Subject: Conditional Work Plan Approval for SLIC Case RO0003076 and GeoTracker Global ID T10000003066, Waste Management, 6175 Southfront Road, Livermore, CA 94550

Alameda County Environmental Health (ACEH) staff has reviewed the case file for the above-referenced site including the recently submitted document entitled, "*Work Plan for Additional Investigation, Former Waste Management Facility, 6175 Southfront Road, Livermore, California,*" dated September 7, 2011 (Work Plan). The Work Plan, which was prepared on behalf of Waste Management of Alameda County, Inc. by Tetra Tech Geo, presents plans for soil vapor and groundwater sampling.

Attachment 1

TITLE: Plot Plan, Previous Sample Locations and Proposed Supplemental Sample Locations			
LOCATION: 6175 Southfront Road Livermore, California			
	CHECKED:	TC	FIGURE: 4
	DRAFTED:	XH	
	FILE:	117-240209101	
	DATE:	08-22-13

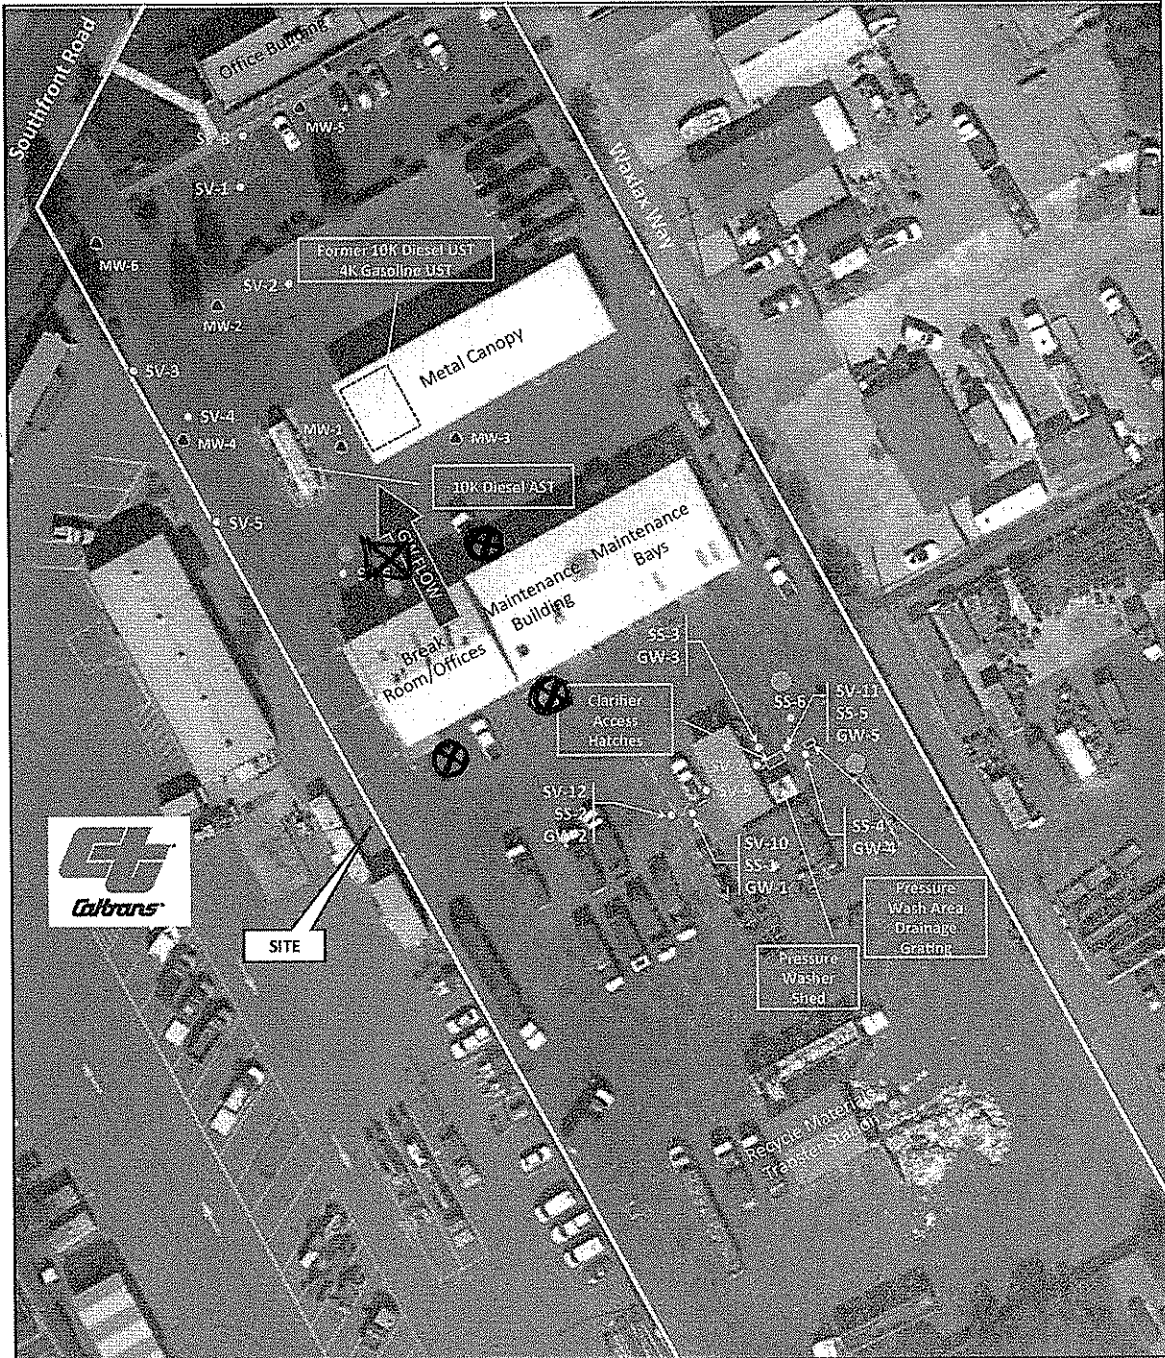
2. **Vinyl Chloride in Soil Vapor.** In correspondence dated June 22, 2011, ACEH requested that you conduct additional investigation including soil vapor sampling to identify the extent and source of vinyl chloride in soil vapor and other media. The Work Plan proposes the collection of two soil vapor samples near existing soil vapor sample SV-6. This proposed scope of work is clearly not sufficient to define the extent or source of the contamination. In addition to the two proposed soil vapor sample locations, we request that you collect an additional three soil vapor samples at the locations shown on Attachment 1. We also request that you advance one soil boring adjacent to SV-6 to collect one grab groundwater sample. The grab groundwater sample is to be collected using the protocols proposed in Section 2.3.2 of the Work Plan. The grab groundwater sample is to be analyzed for full scan VOCs using EPA Method 8260 and Total Petroleum Hydrocarbons (TPH) as Gasoline, Diesel, and Motor Oil using EPA Method 8015. Please present the results in the Site Investigation Report requested below.

3. **Total Petroleum Hydrocarbons in Groundwater.** The proposal to advance two soil borings in the wash rack area to collect grab groundwater samples is generally acceptable. In each soil boring, we request that soil samples be collected for laboratory analysis from any zones where visible staining, odor, or elevated PID readings are observed. If no visible staining, odor, or elevated PID readings are observed in the borings, a soil sample is to be collected for laboratory analysis at a depth of 5 feet bgs. The soil samples are to be analyzed for TPH as diesel and motor oil using EPA Method 8015M. Please present the results in the Site Investigation Report requested below.

- ⊗ Additional Soil Vapor Sample Location
- ⊠ Additional Groundwater Sample Location
